Service Bulletin
No. MSB-E4-024/1

MANDATORY SERVICE BULLETIN

Waste gate – Spring loaded circlip

Engine type: E4
Engine model(s): E4, E4P
Serial number(s): all

Example: Turbo charger for engine configuration "-A" with new spring loaded circlip

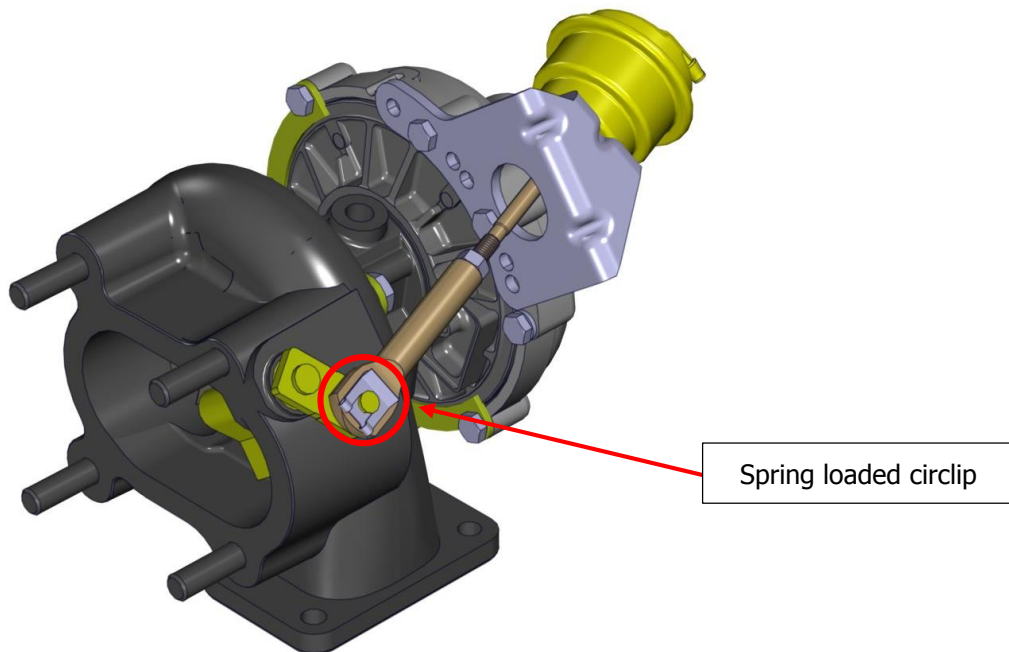
This Service Bulletin describes the replacement of the waste gate circlip, which prevents the waste gate actuator connection rod from disconnecting from the waste gate bolt of the turbo charger. An improved circlip design prevents the incorrect installation of the circlip.

Replace the circlip DIN6799-5 with the spring loaded circlip E4A-41-100-801.
